NM1-19

Closure/Post-Closure Plan
with updated FA

Re: Response to Comments, Review of Closure and Post-Closure Plan for
Gandy-Marley Landfarm/Landfill Permit NM1-19

Closure/Post-Closure Plan Gandy-Marley Landfarm/Landfill, NM1-19

Figure 2

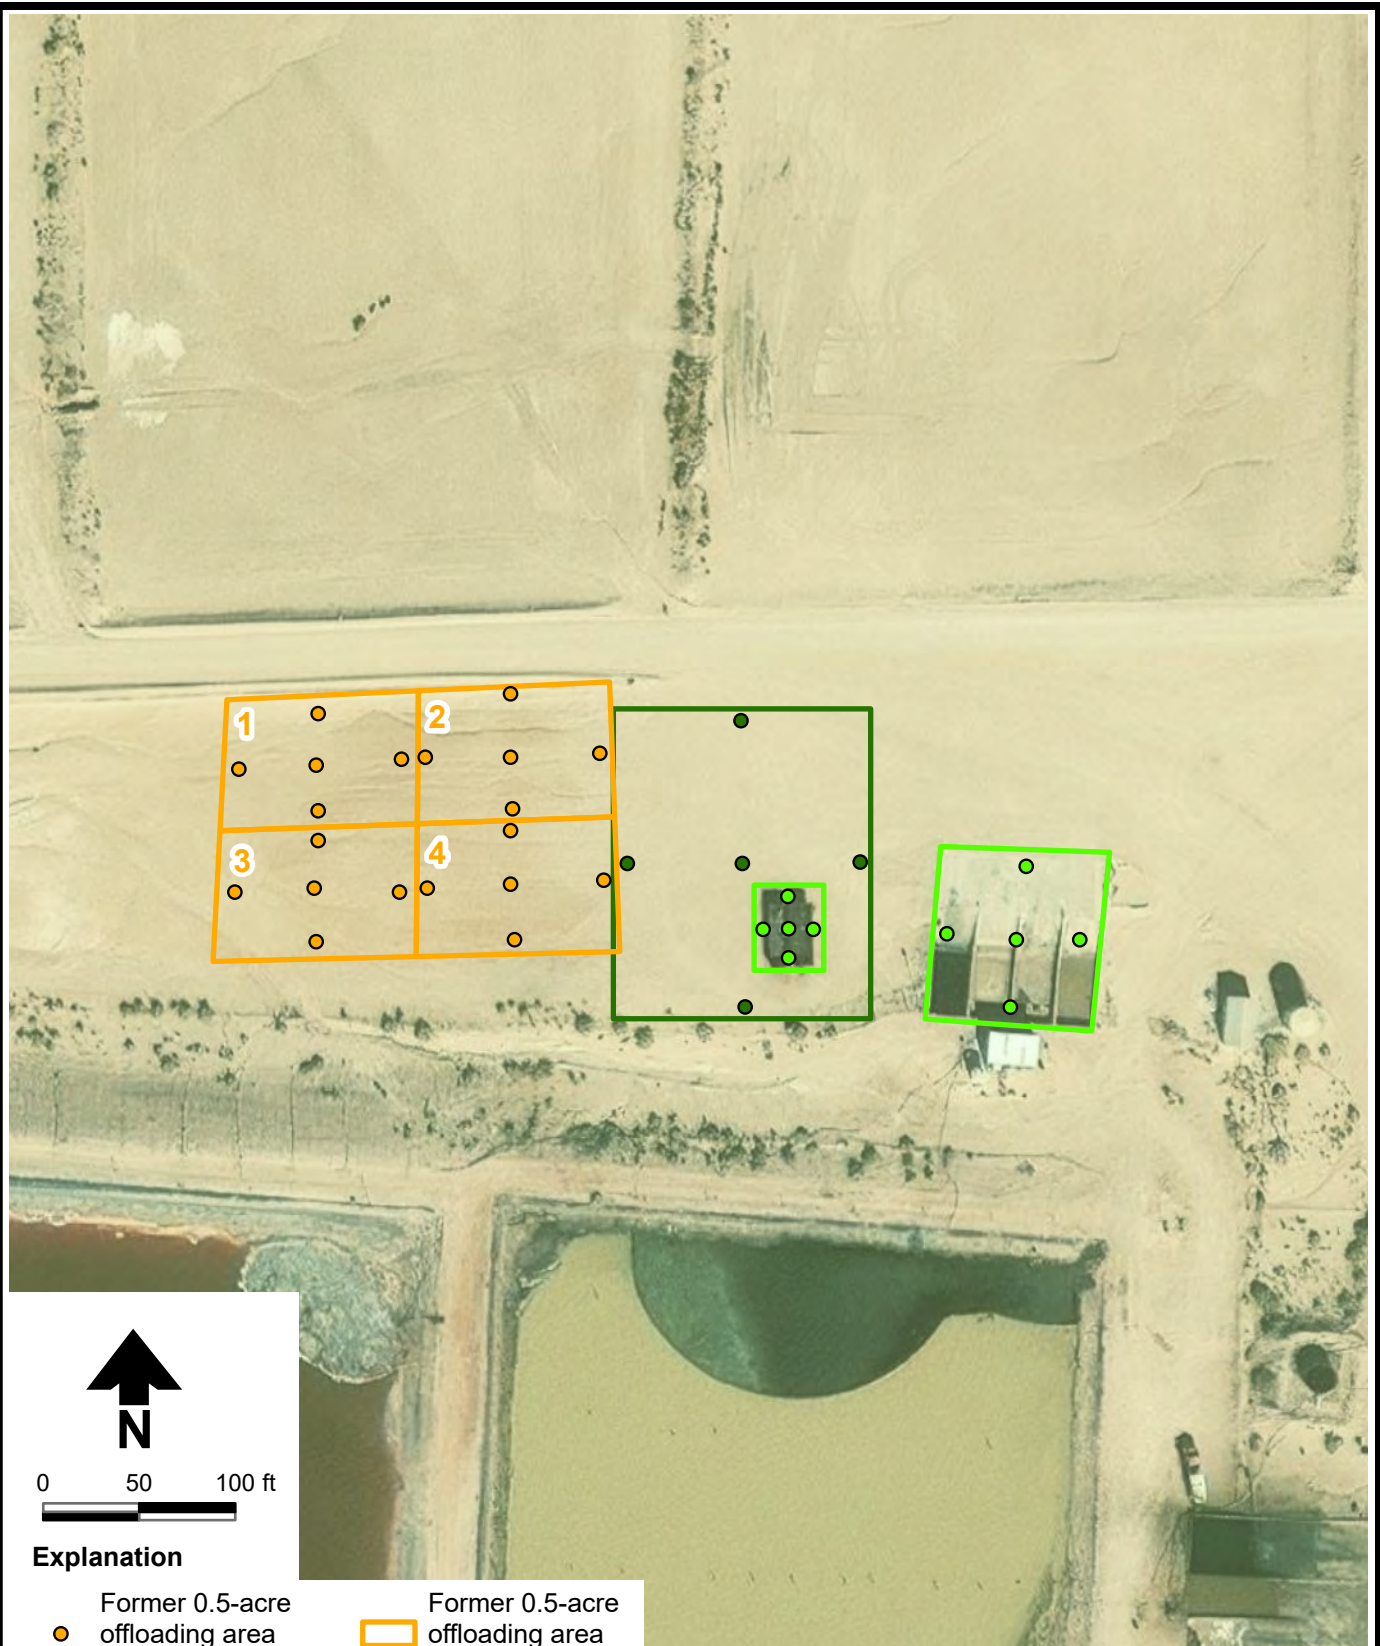
4. *Section 2.1. Oil Treatment Facility Closure [19.15.36.18(C)(1) NMAC]. Oil handling and treatment facilities that will require removal include three concrete bays, two AST batteries, and an individual AST. The concrete bays are referred to as the Artesia pits, mud pits, and washout bays (Figure 1). The Artesia pits are used for waste offloading and separating of liquids from solids: Add the cement tank bottoms stabilization trough, permitted in 1996 that is located between the ancillary tank and the AST battery, NE of the washout bays.*

5. *Section 2.1. Oil Treatment Facility Closure [19.15.36.18(C)(1) NMAC]. After the tank batteries, ancillary tank, concrete bays, offloading area, truck pullout area, and former pond are removed the soil beneath them will be field screened and sampled to determine whether impacted soils exceed closure standards and need to be removed (Section 4). Soil samples will be collected and sampled for the following constituents: Again, Add the cement tank bottoms stabilization trough. Also cite 19.15.36.18.C(1) NMAC for this soil sampling.*

The stabilization trough facility has been added to Section 2.1 and Figure 2.

The stabilization trough facility has been added to Section 2.1, and its sampling grid has been added to Figure 2. Language has also been added to explicitly call out 19.15.36.18(C)(1) NMAC as the reference for the soil sampling.

DRAWING TITLE: **ULTIMATE COVER PLAN CROSS-SECTIONS**

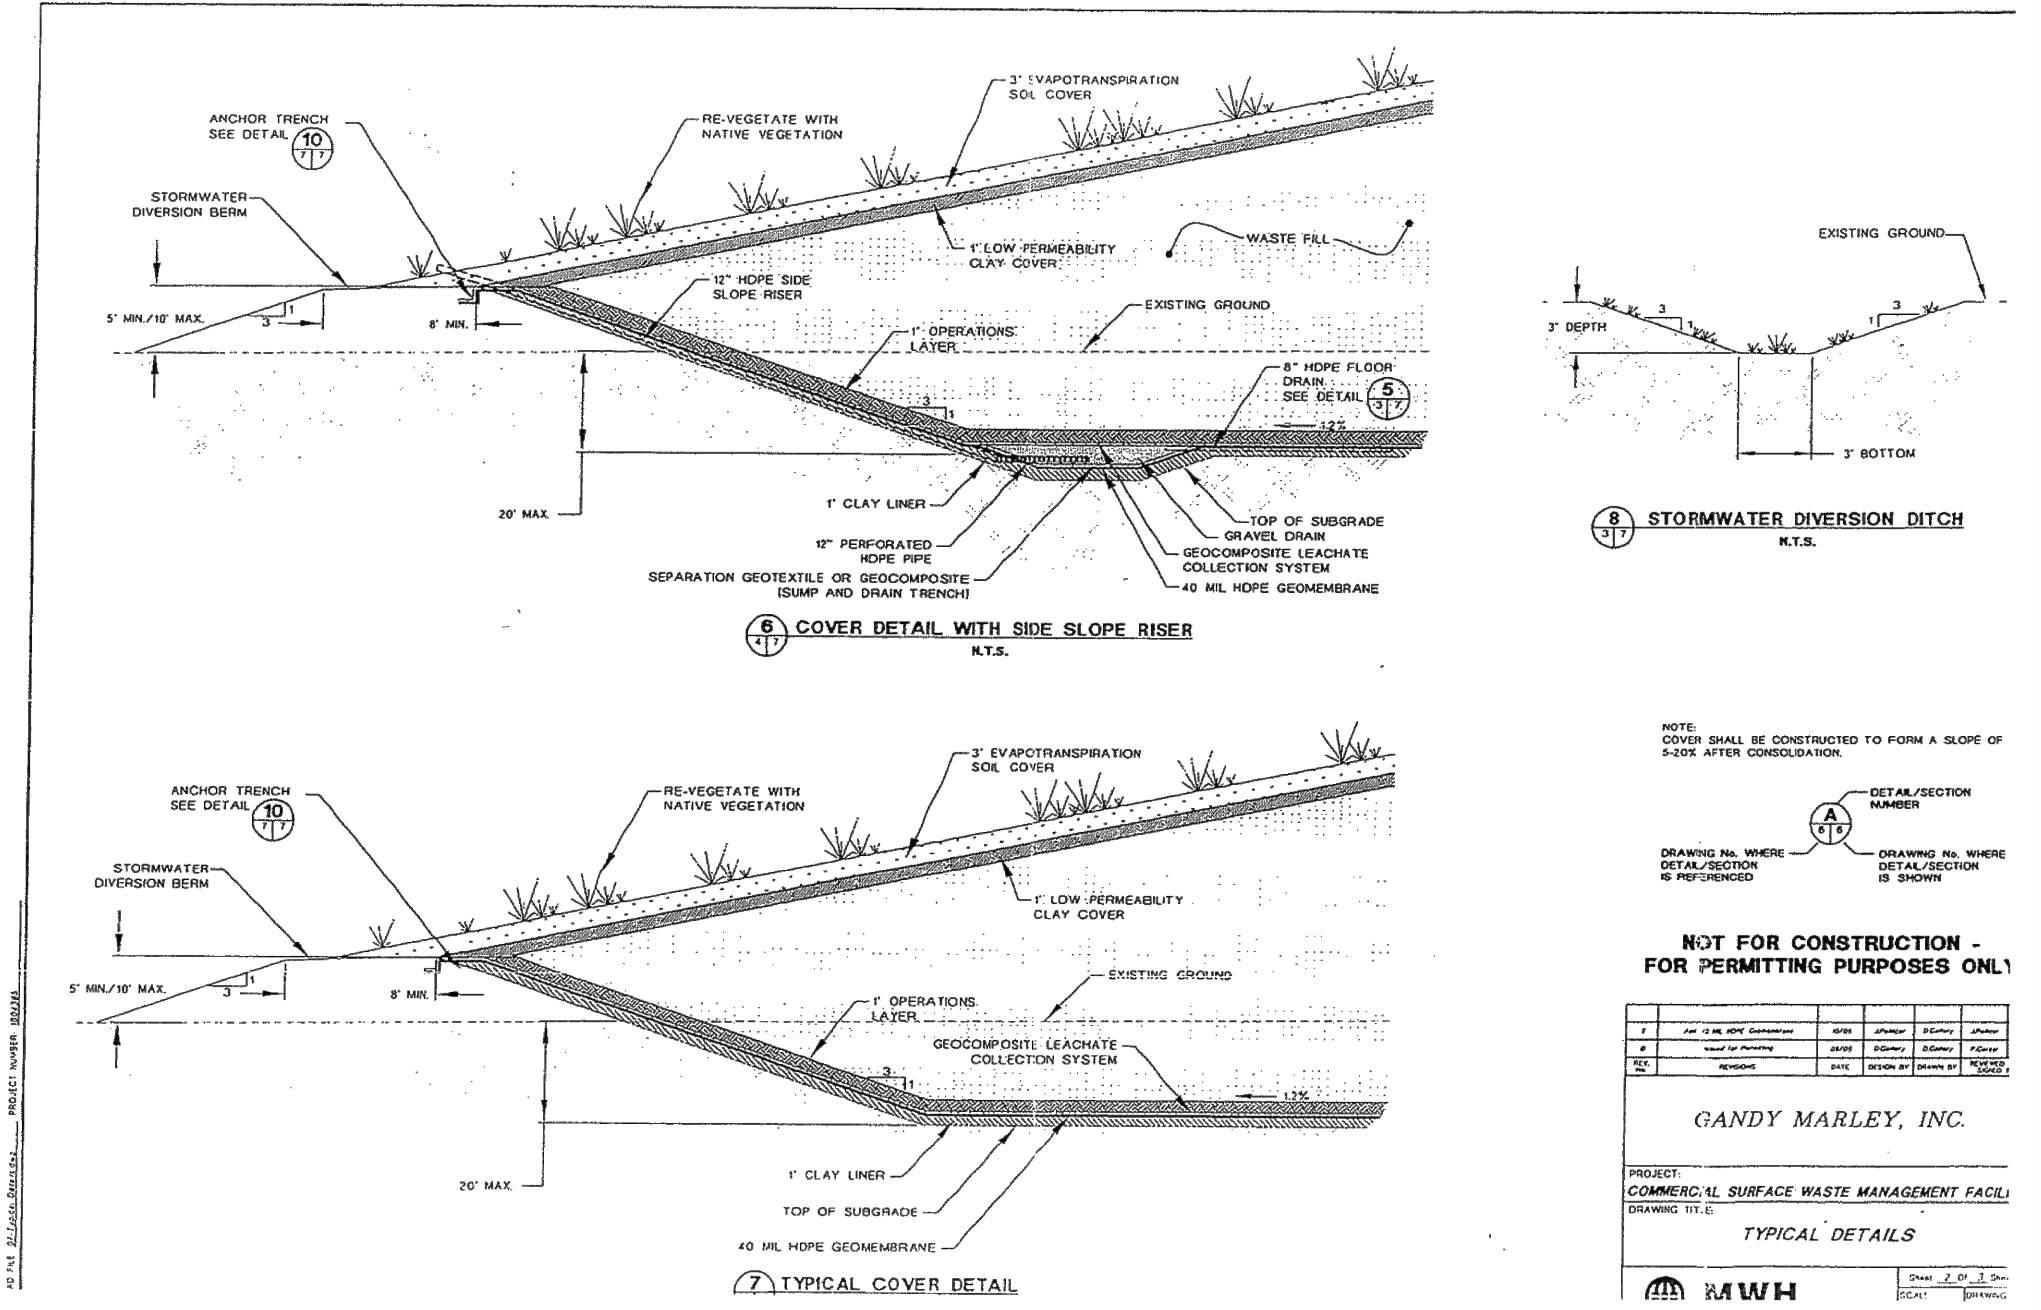
2. *Section 2. Closure Plan. Appendix B contains design drawings for the landfill. MWH completed the landfill design, dated September 2005. Sheet 6 of the MWH design is the closure plan for landfill, including its final grade: GMI must submit a full set of design drawings for the landfill with new drawings for the double lined leak detection system and revisions to the other facility drawings to incorporate changes that the double liner and leak detection systems will affect. For instance, the previously permitted drawings have reference symbols on cross-sections or map views that refer to details of the older, single liner drawings. All design drawings must be stamped by a professional Engineer (PE).*

4, 2005 permit application (NMEMNRD, 2006). Sheet 6 is the ultimate cover plan, with cross sections: As described above, GMI must submit a full set of design drawings for the landfill.

7. *Section 2.2. Landfill Closure [19.15.36.18(C)(2) NMAC]. The cover will be contoured to promote drainage and prevent ponding of stormwater with final grades of the top surface ranging from 5 to 20 percent, meeting the requirements of 19.15.36.18(C)(2)(a) NMAC. Side slopes will not exceed a twenty percent grade (4 feet horizontal to 1 foot vertical) to prevent erosion: This does not meet the requirement of Paragraph (8) of Subsection C of 19.15.36.14 NMAC: "The operator shall properly close landfill cells, covering the cell with a top cover pursuant to Paragraph (8) of Subsection C of 19.15.36.14 NMAC, with soil contoured to promote drainage of precipitation; side slopes shall not exceed a twenty-five percent grade (four feet horizontal to one foot vertical), such that the final cover of the landfill's top portion has a gradient of two percent to five percent, and the slopes are sufficient to prevent the ponding of water and erosion of the cover material."*

A full set of design drawings is provided as Appendix B. It includes engineering of the existing and active southern portion of the landfill and double lining of the north portion of the landfill that has yet to be constructed. The drawings are stamped by a professional engineer licensed in New Mexico.

A full set of design drawings is provided as Appendix B.

The range of the top surface final grade has been corrected to read 2 to 5 percent instead of 5 to 20 percent, and the final grading side slopes are depicted to be a maximum of 4:1 or at 25 percent slope.
